Application No. UP-686-05

Premier Properties USA, Inc.

MEMORANDUM

SUBJECT: Application No. UP-686-05, Premier Properties USA, Inc.

PRELIMINARY INTERNAL
CIRCULATION PLAN
C2.2

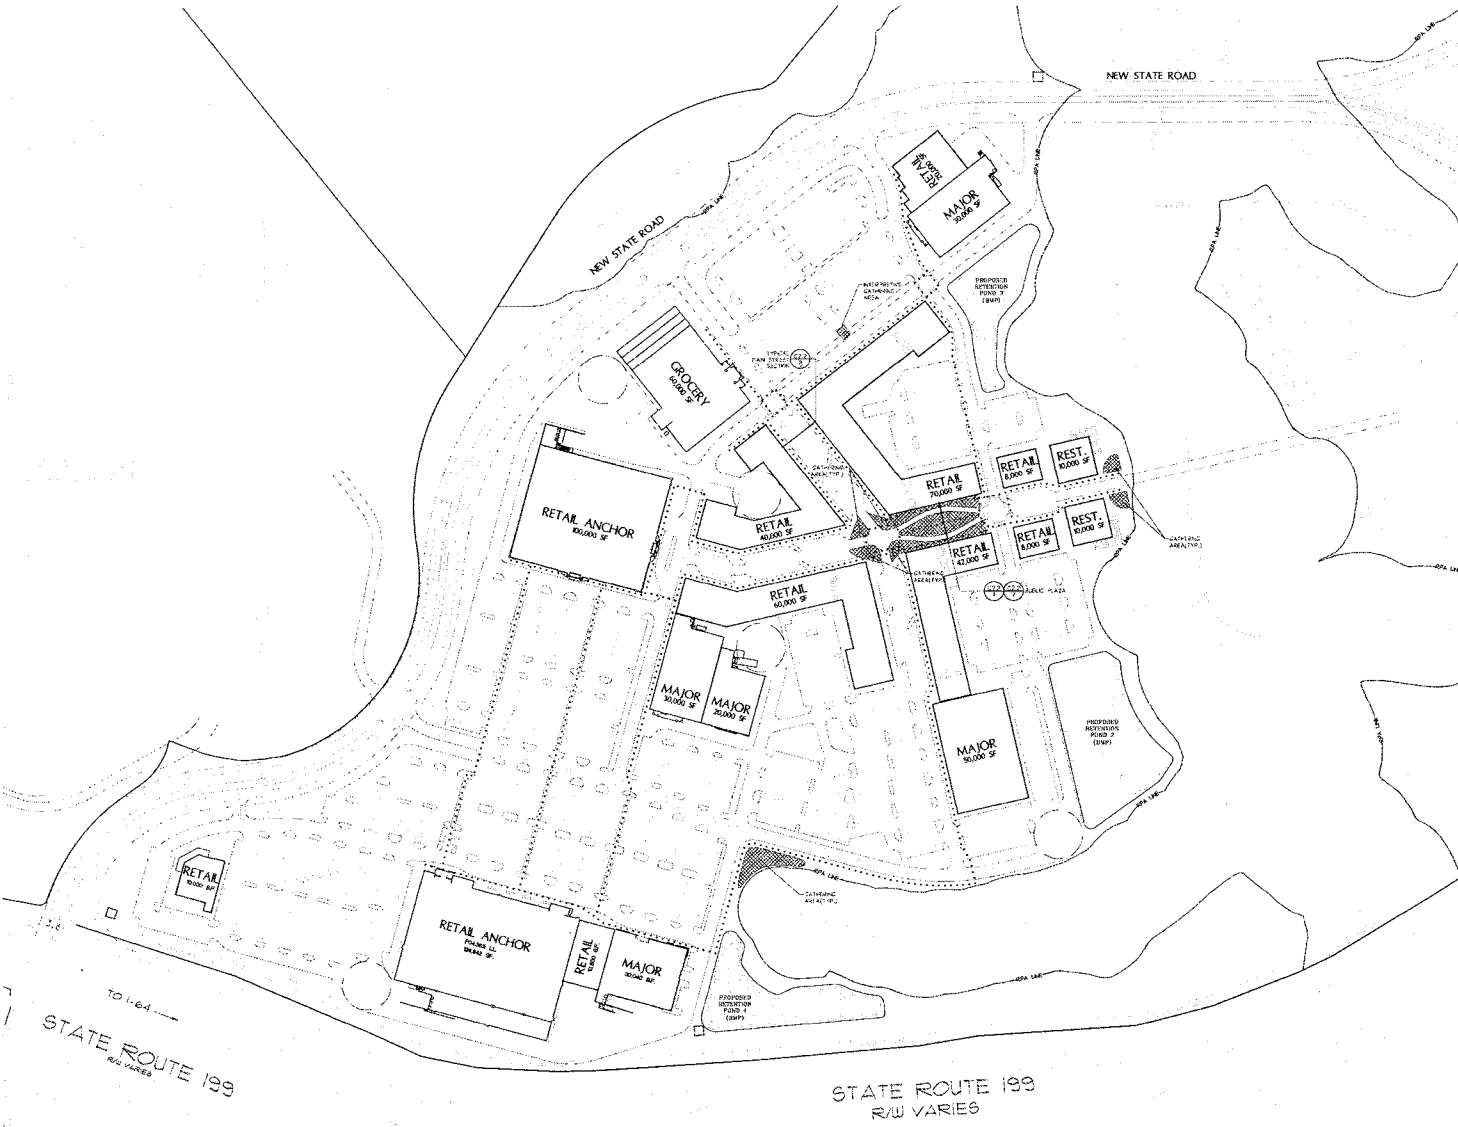
10. Plan sheet C2.2 indicates proposed pedestrian connections across the complex. Staff is of the opinion that additional connections are needed to afford safe pedestrian circulation along the major access ways within the complex. Staff is recommending that pedestrian access ways be designed as a combined 10-foot wide landscape and sidewalk island with a minimum 6-foot wide unbroken planting area and minimum 4-foot wide sidewalk for the majority of the access ways. For the main, centrally located east-west access across the site staff recommends a minimum 15-foot island containing a sidewalk at least 5 feet wide and a minimum 10-foot landscape area. A sketch plan diagramming the recommended access ways and an associated approval condition are proposed to address this issue.

5. Pedestrian access and parking lot landscape dividers shall be located as depicted on the plan sheet labeled "Staff amendments," Sheet C2.2 and dated October 10, 2005, a copy of which is included in this resolution by reference. The ultimate

site design shall also include any additional pedestrian ways and/or landscape dividers as may be deemed required in the course of final site plan review. The pedestrian access way labeled “major pedestrian access way” shall be designed as a minimum 15-foot wide landscape island containing a minimum 5-foot wide sidewalk adjacent to a minimum 10-foot wide landscaped area. All other delineated pedestrian access ways shall be designed as minimum 10-foot wide islands containing minimum 4-foot wide sidewalks adjacent to minimum 6-foot wide landscaped areas.
